ADC PARKS & GREENSPACE ARBORICULTURE

PLANNING APPLICATION: AW/262/15/T

ADDRESS: Footpath outside 4 Hunters Close The Ridings Aldwick

BRIEF DESCRIPTION: Raise crown by 2m from lowest point by removing epicormic growth & thinning by 33% to 1 No. Horse Chestnut tree.

Figure 2 Positions of final cuts

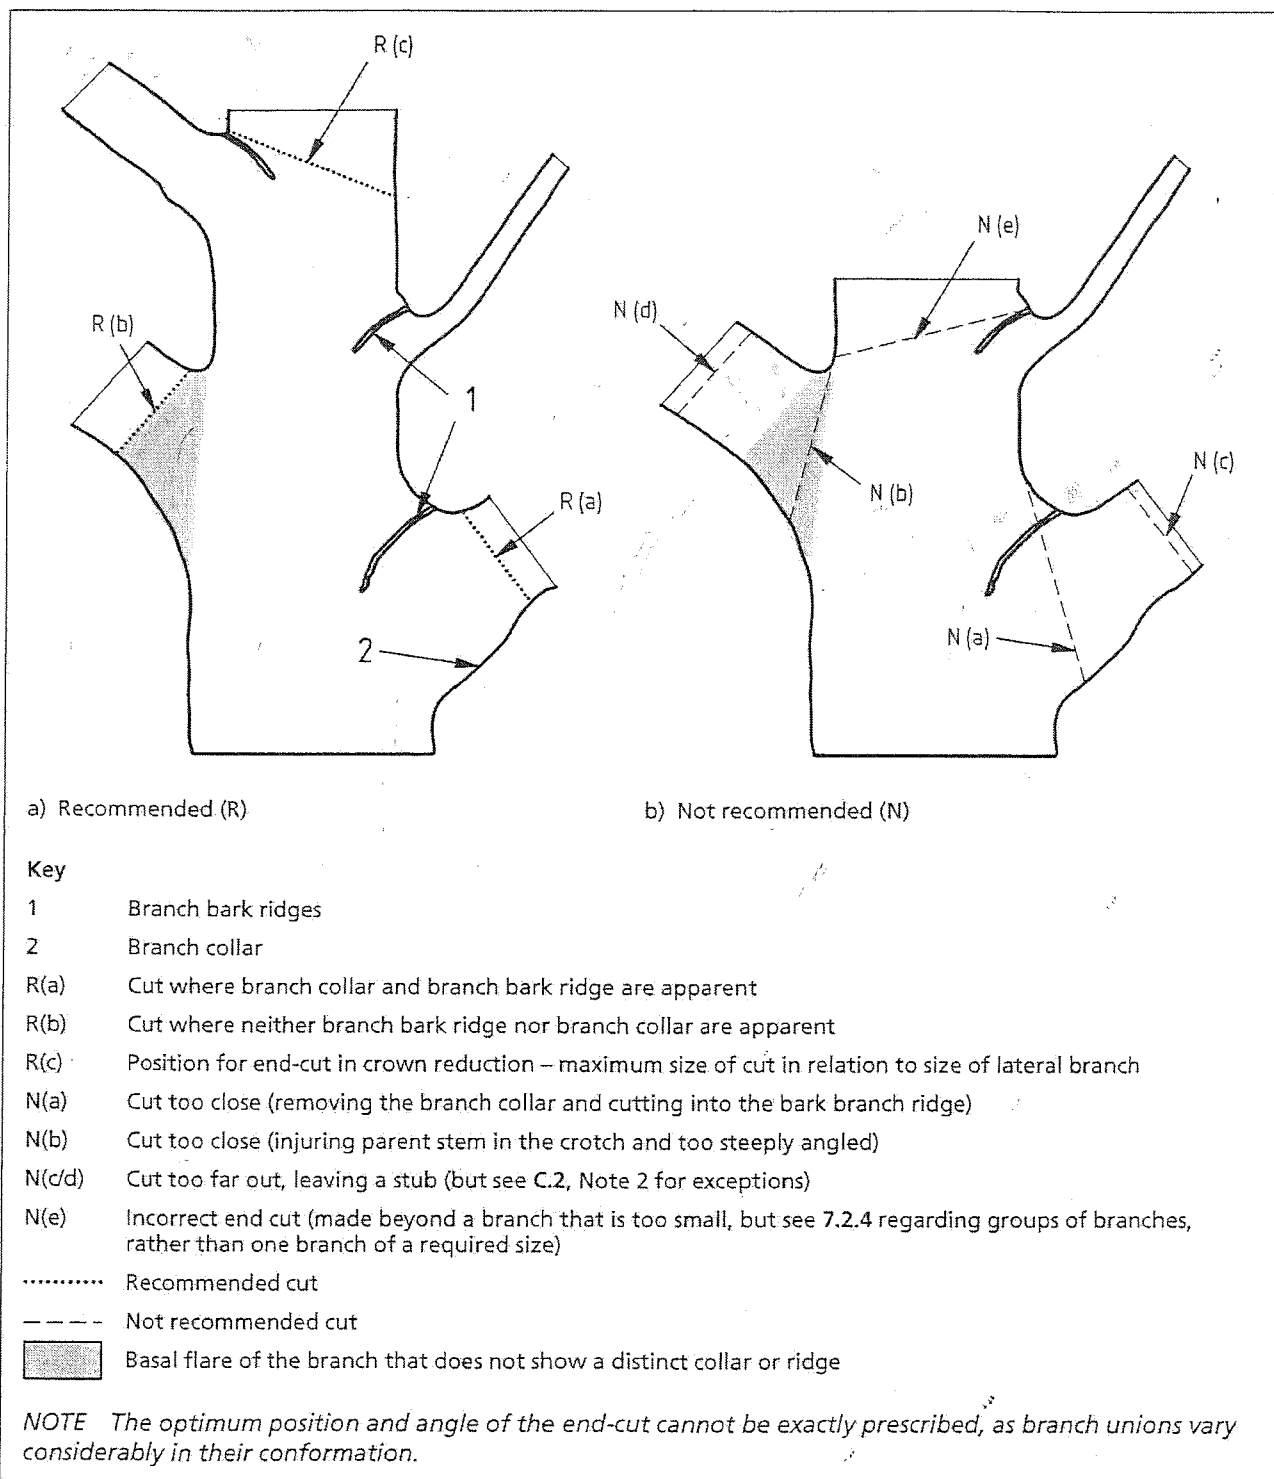
All side branches to be retained should be at least **1/3rd** in diameter of the removed branch. Pruning cuts must be flat and smooth, kept as small as possible by cutting at an optimum angle and should not exceed **100mm** in diameter.

Figure 4 Diagrammatic illustration of crown reduction

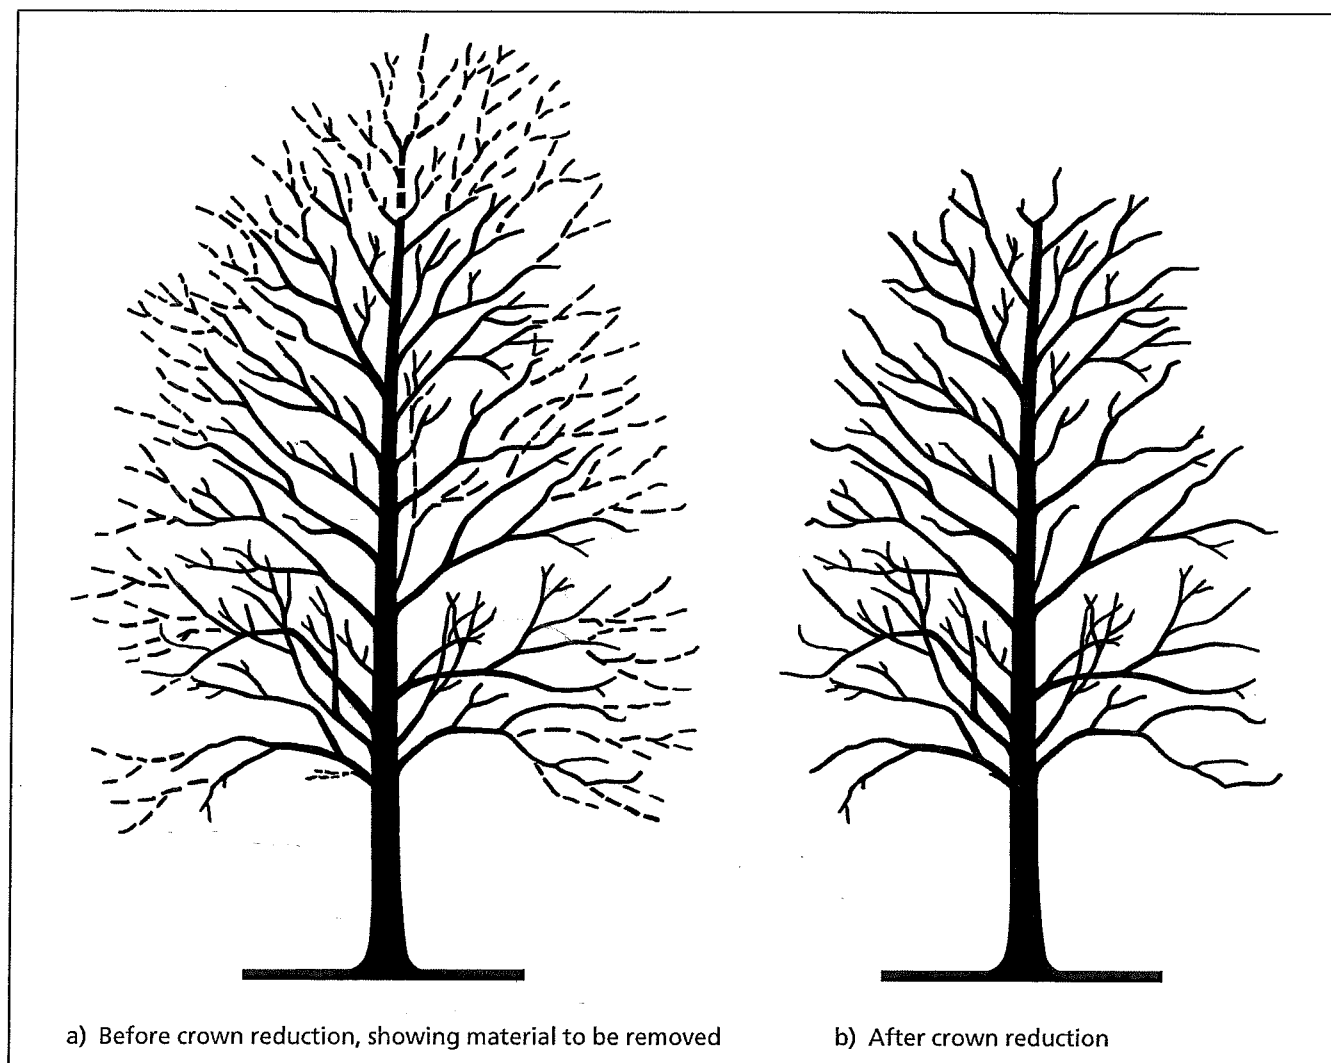
Crown Reduction
